ADDENDUM NO. 3
TO
BID DOCUMENTS BID #2223-14
BARTLEM PARK SOUTH – PHASE 1
Cheshire, CT
January 11, 2023
NOTICE TO BIDDERS

1. Detail Sheet L905 revised, see attached.

3 **CIP CONCRETE RETAINING WALL AT BANDSHELL**
 NOT TO SCALE

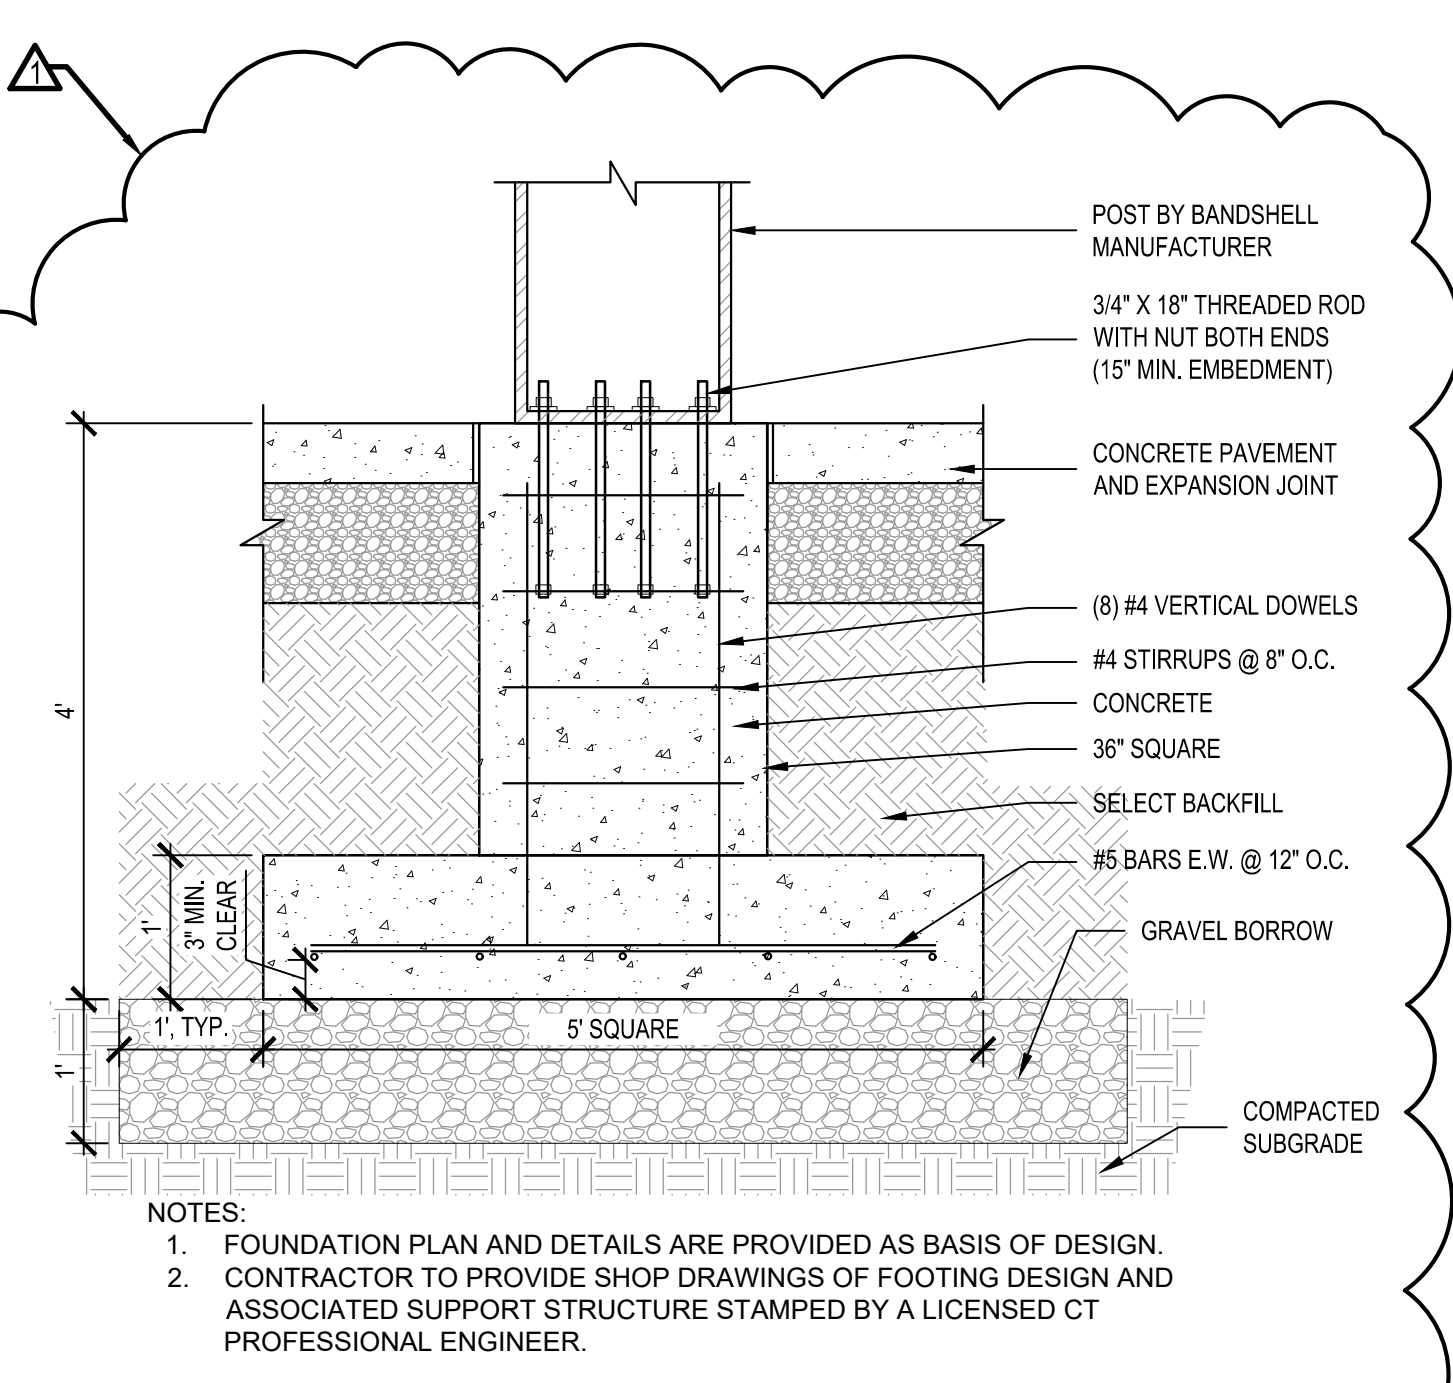
- Detail #3- CIP Concrete Retaining wall at Bandshell
- Detail #4- Post Footing Detail
- Detail #5- Mountable Curb

3 SYNTHETIC TURF- NAILER CURB
 NOT TO SCALE CT-BP-42

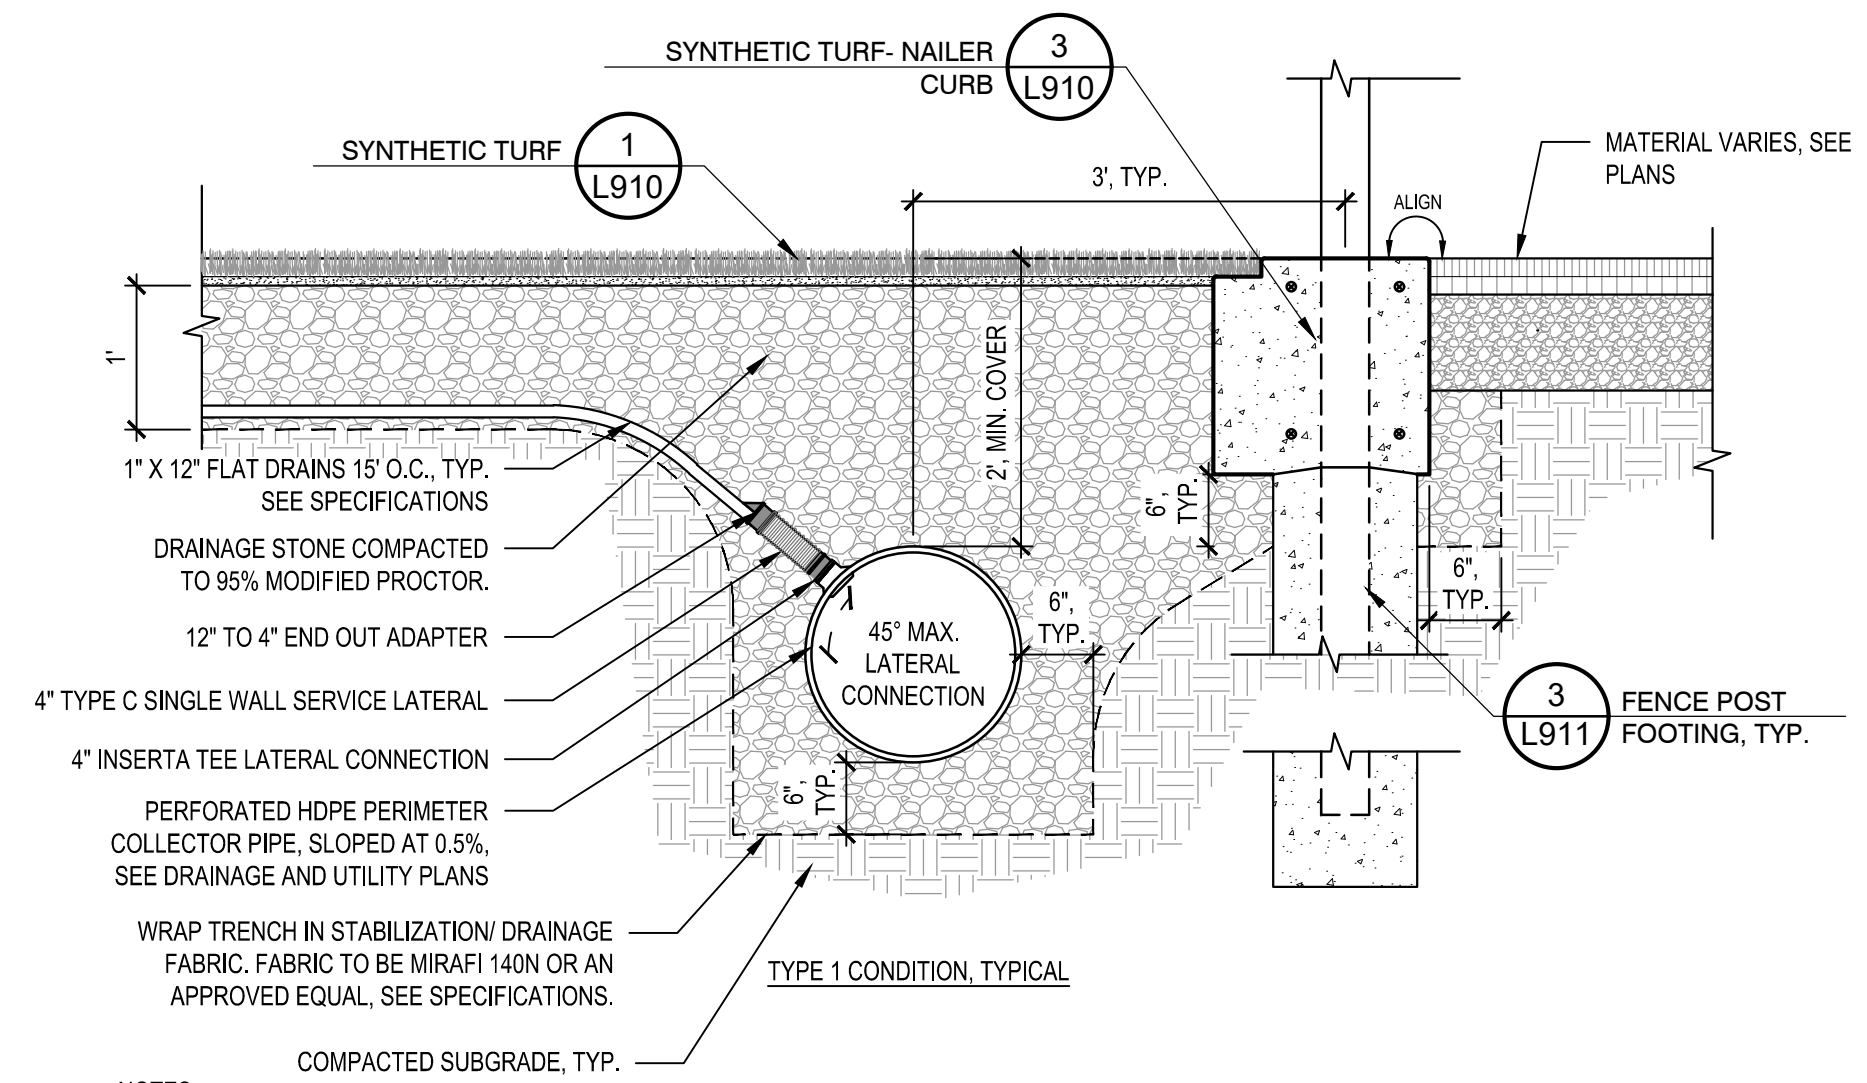
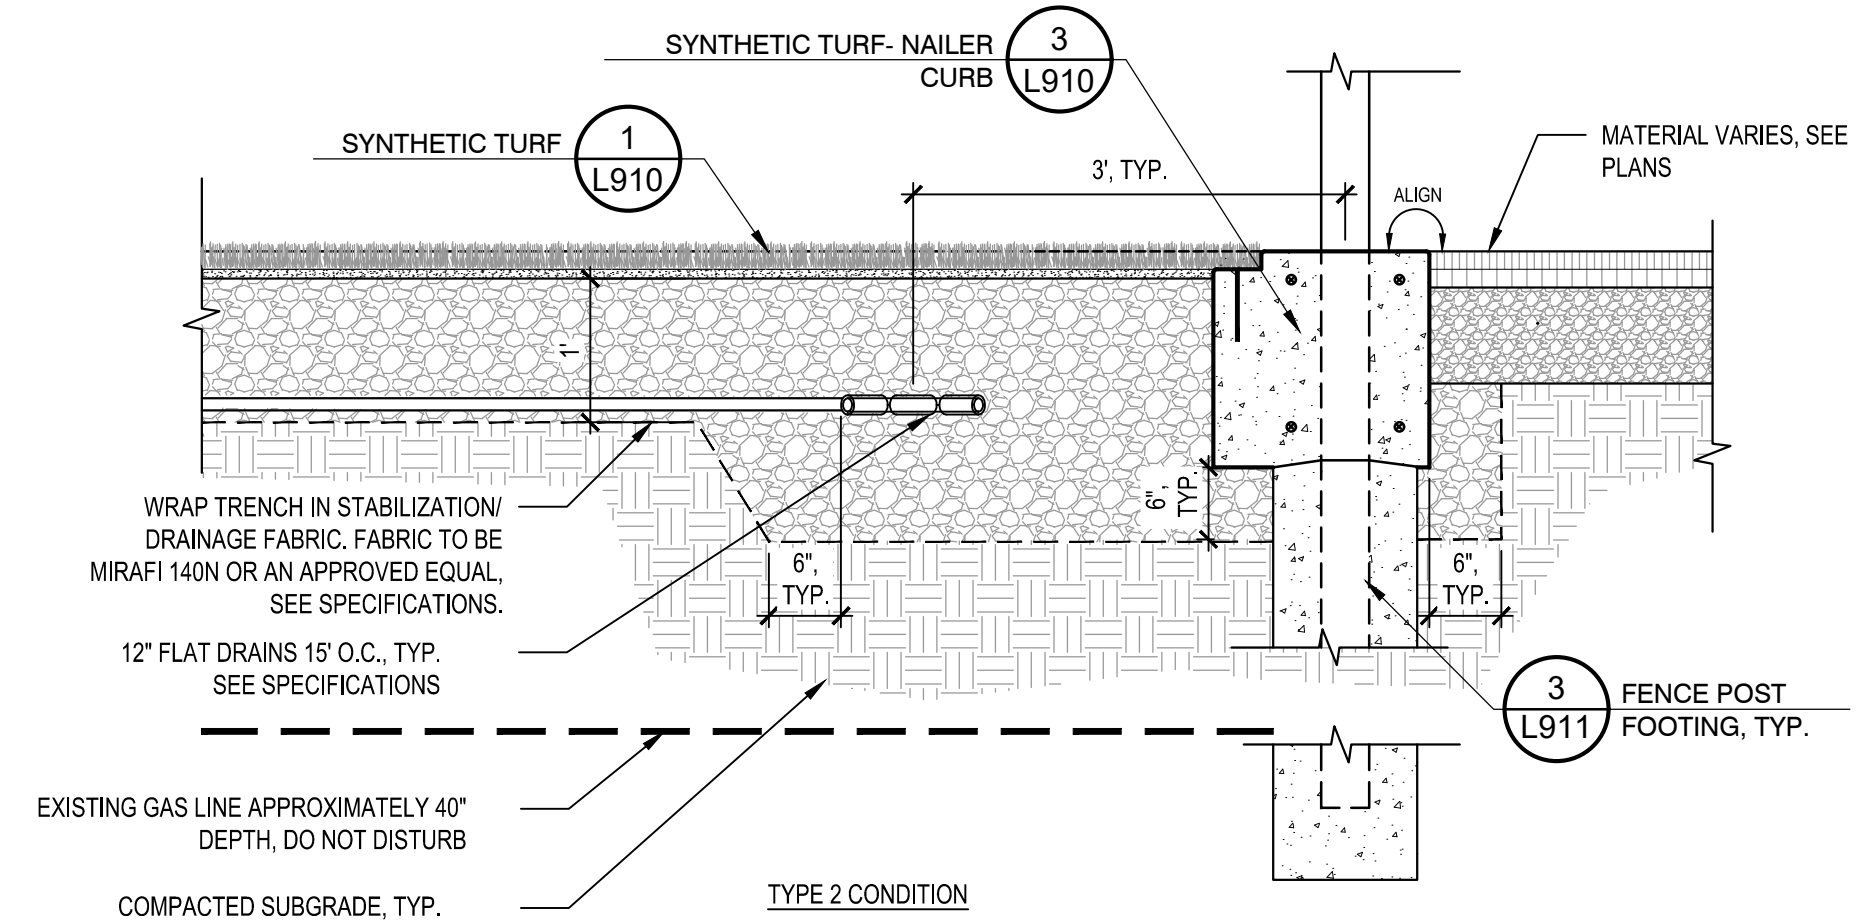
2. Detail Sheet L910 revised, see attached.
DELETE: Sheet L910
ADD: Sheet L910 revised 02/03/2023
 - Detail #2- Collector drain.
 - Detail #3- Synthetic Turf- Nailer Curb
 - Detail #5- Synthetic Turf- Nailer Curb at Posts

3 FENCE POST FOOTING, TYP.

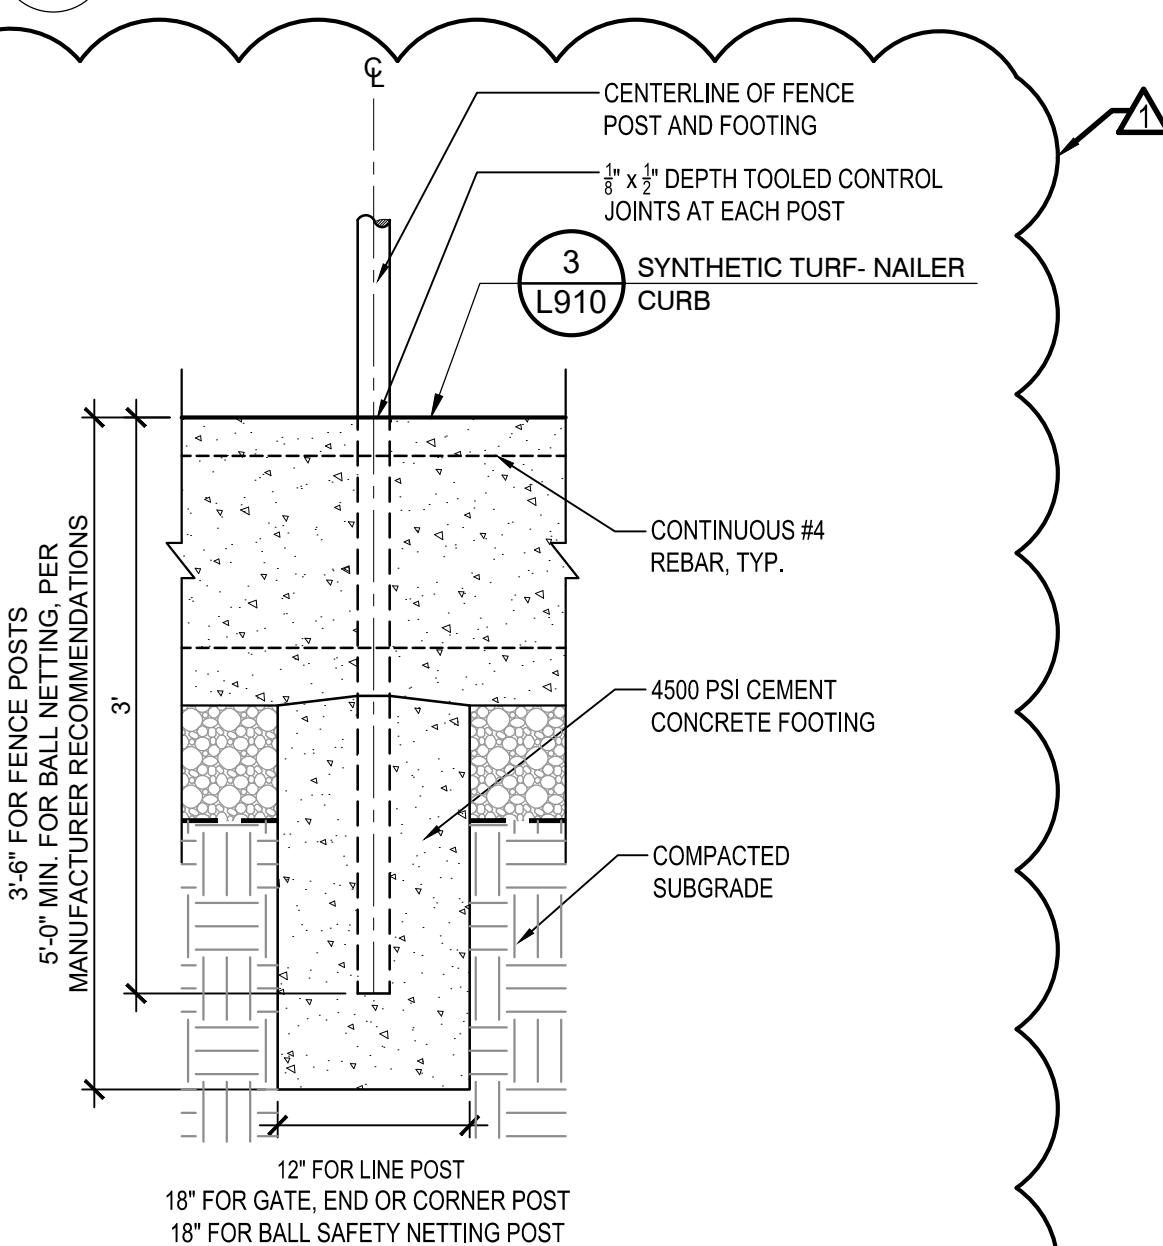
3. Detail Sheet L911 revised, see attached.
DELETE: Sheet L911
ADD: Sheet L911 revised 02/03/2023
 - Detail #3- Fence Post Footing, Typ.
